Shearwater Petrel, Petrel 2, and Perdix Firmware v34 Release Notes

DocRev: A

Date: 2016-06-01

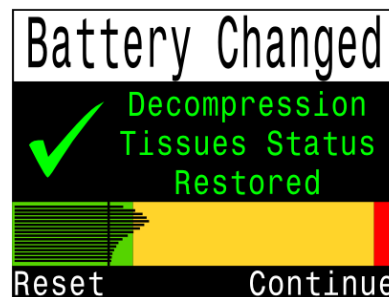
NEW FEATURE: After changing the battery, the current deco tissue loading is shown on the Tissues Restored screen.

NEW FEATURE: On the Tissues Restored screen, a shortcut to reset the tissues is given. If Reset is chosen, a prompt will be displayed to confirm.

The tissues bar graph is now shown on the Tissues Restored screen

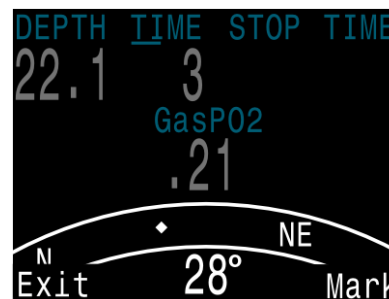
CHANGE: Compass mark heading menu moved to reduce button presses. Also, the compass can now be viewed while marking. Operation: when viewing compass a left button press brings up an “Exit Mark” menu. Right press marks compass, Left press exits to main screen. Previously had to navigate to regular menus to mark the compass.

The mark heading command now requires less button presses

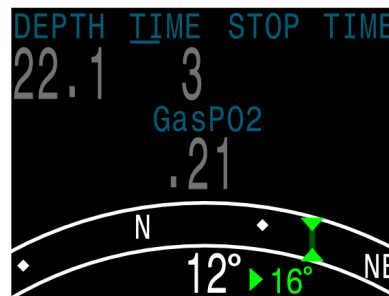
IMPROVEMENT: When a heading is marked, the display now shows the offset angle between the current heading and the marked heading. This is useful for navigating patterns. For example, a box pattern requires turns at 90° intervals, while a triangle pattern requires turns at 120° intervals.

The offset between current and marked heading is now shown (in this example 16°)

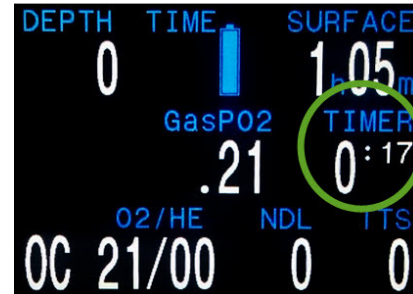
- **NEW FEATURE:** Added a mini compass as an optional display on the center row.
- **NEW FEATURE:** The current compass numerical value (azimuth) is shown on the “Mark Heading” menu.
- **CHANGE:** After marking a heading, if the new mini-compass is shown, returns to the main screen. If mini compass is not shown, returns to the compass screen as before.
